# Agenda

## Planning Decisions Committee

6.30pm, Tuesday 3 May 2022

1. This report provides the Planning Decision Committee with an assessment of a planning application submitted for 55 to 57 Stewart Street, Richmond. The report recommends approval of the application subject to a number of conditions.

Image: 2pm Shadow impact Decision plans  
Source: Carr Architecture

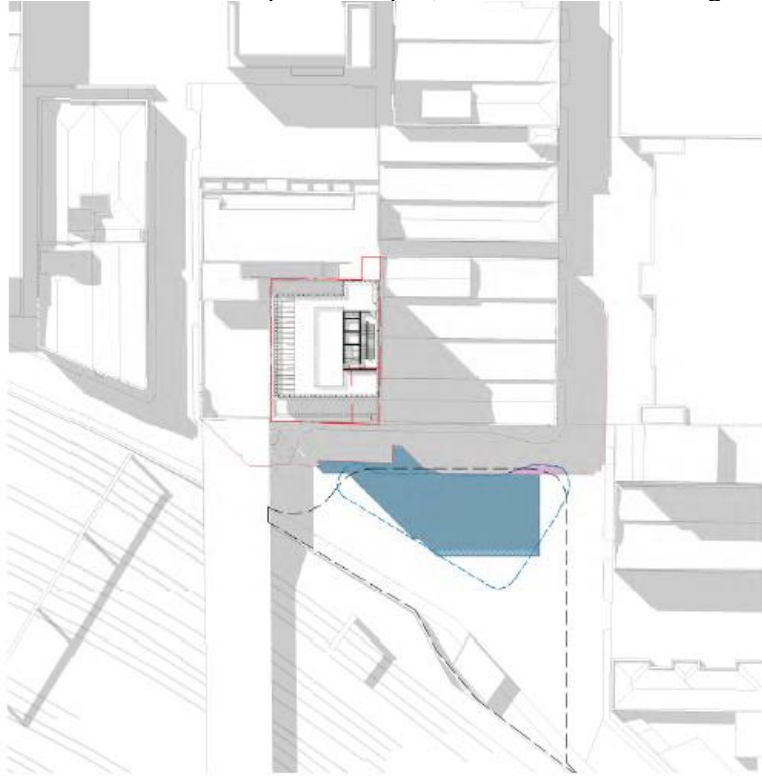
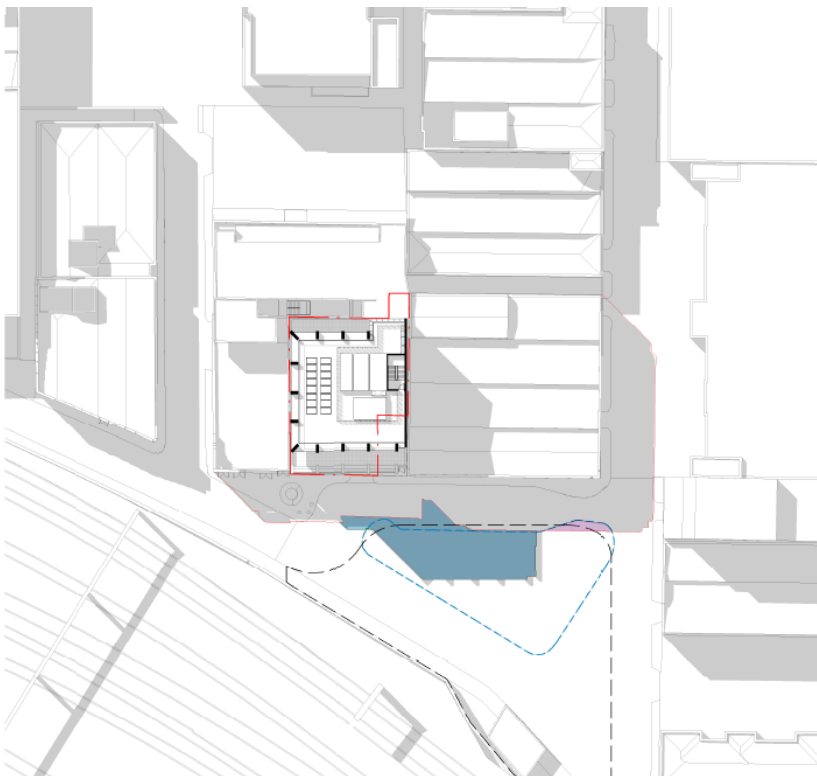
At the equinox, the pocket park was previously experiencing near full shadow at 2pm and about half shadow at 1pm and 3pm, as shown in the image below.

205. Subject to the Section 57a changes, most notably reducing the overall height from 10 to 8 storeys, the pocket park now experiences substantially less shadow at equinox in particular at the most impactful 2pm where shadow has reduced by approximately 40%. The shadow impacts at equinox are now considered to be acceptable to allow for enjoyment of the park at equinox.

Image: 1700mm screening to terrace on western boundary as well as GL02 (screened) glazing to upper levels.  
Source: Carr Architecture

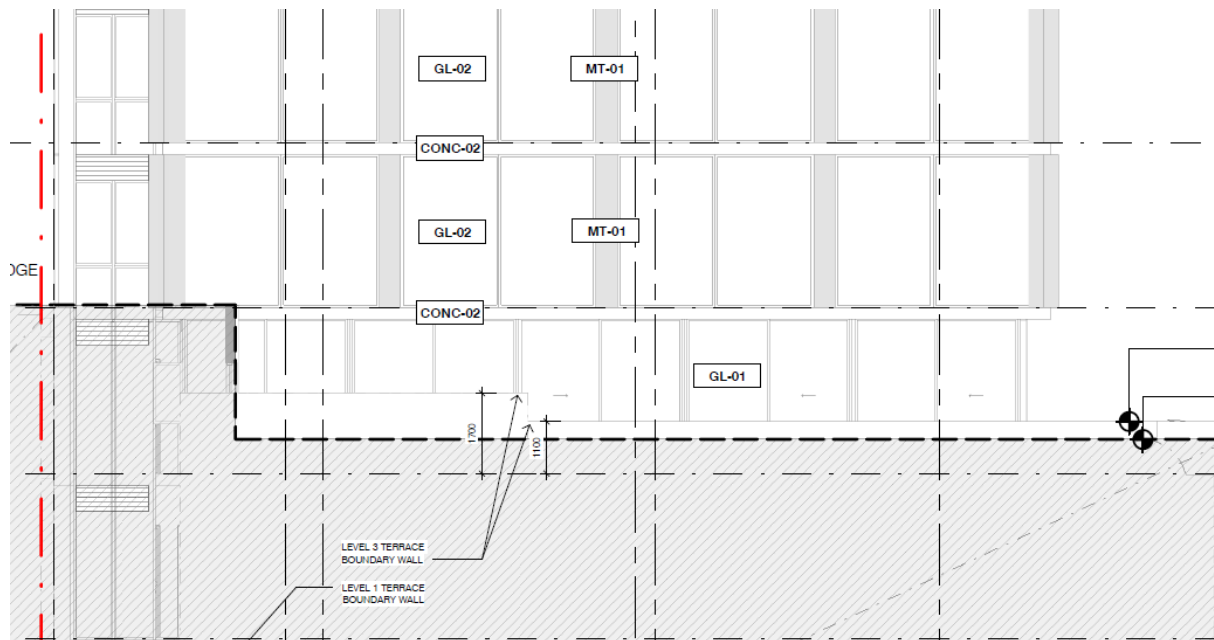
215. It is also noted that overlooking concerns were raised by objectors and the decision plans address these concerns by providing full height obscure glass windows to the north facing windows as shown on the elevations and a 1700mm screen to the terrace where it faces sensitive interfaces as shown in the image below.

Figure 26: Apt. type 2A

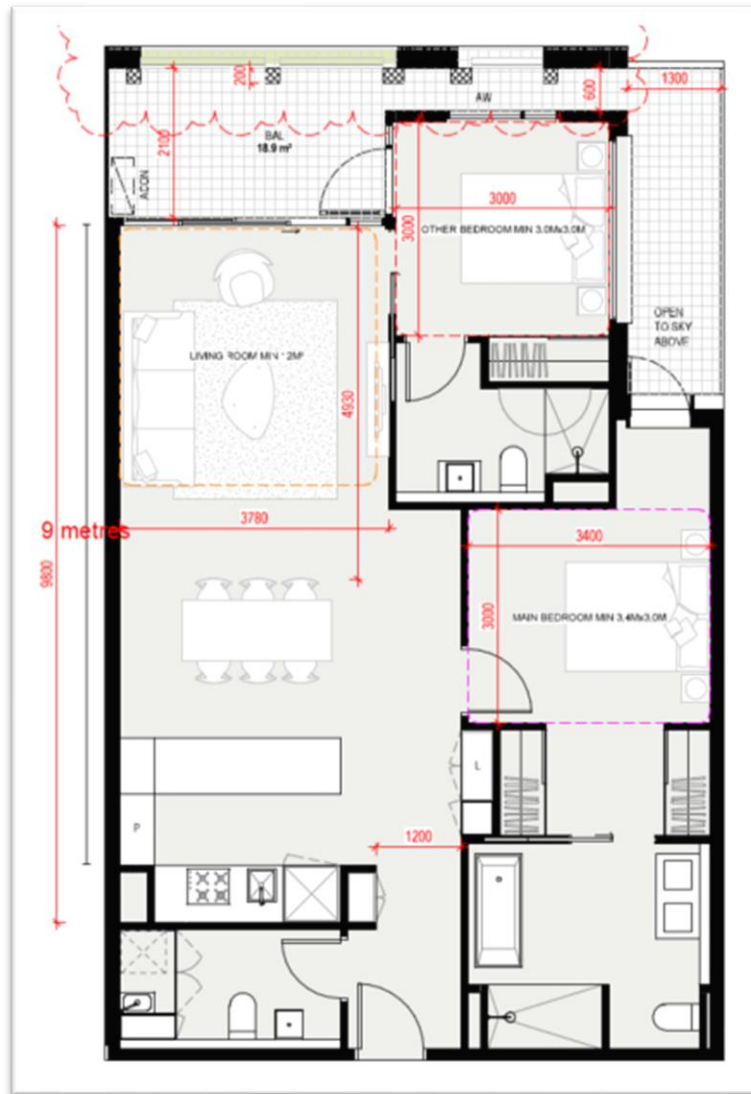
317. The room depth should be measured from the external surface of the habitable room window to the rear wall of the room.
318. There is one Apt. type that does not meet this requirement (Apt. type 2A). A total of 6 apartments are proposed with this layout, which is demonstrated in Figure 25, where the overall room depth is 9.8m. In this instance, all other requirements outlined above are met, with the living area open plan in design, the kitchen located furthest from the window and the finished floor level a minimum of 2.7m in height.

319. Also demonstrated in Figure 26 is the 9m depth (the darker line), which would encompass the majority of the kitchen, with the only exception being the stove/sink and fridge area. The food preparation area would be included in this dimension. On this basis, and as these dwellings are all north-facing and would therefore receive a good extent of solar access throughout the day; a variation to the Standard for four of these 6 dwellings is considered appropriate. (Apts. 201, 202, 301, 302).

320. However, daylight levels in the living rooms of the Level 1 apartments (Apts.101 & 102) are very low, at 44.1% and 42.9% respectively. To increase the daylight levels within these dwellings, a reduction in room depth to meet this Standard is considered necessary. A permit condition will ensure this occurs.

Figure 27: Layout of Apts. 105 & 106

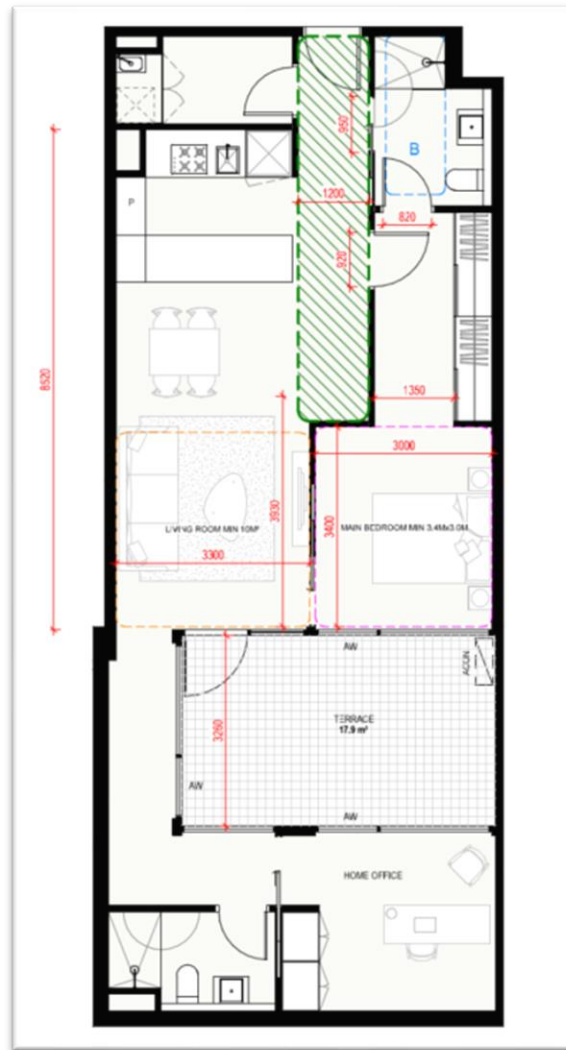
321. Most habitable rooms within the proposed development contain a window within an external wall to the building, with the exception being Apts. 105 & 106. The apartments, as shown in Figure 27, have been designed as 'SOHO' apartments; which refers to 'Small Office Home Office', and are designated as an option for people working from home. An internal lightcourt sits directly adjacent to the bedroom and living room, with a home office extending to abut the southern boundary. This results in no external habitable room windows.
322. Whilst Council's ESD Adviser initially raised concerns with the layout of these dwellings, noting they had limited outlook; the most recent SMP and daylight assessment concludes that these apartments achieve 'best-practice' with regards to daylight. Further to this, as only 2 of the 65 apartments adopt this design, a variation to the Standard is acceptable.
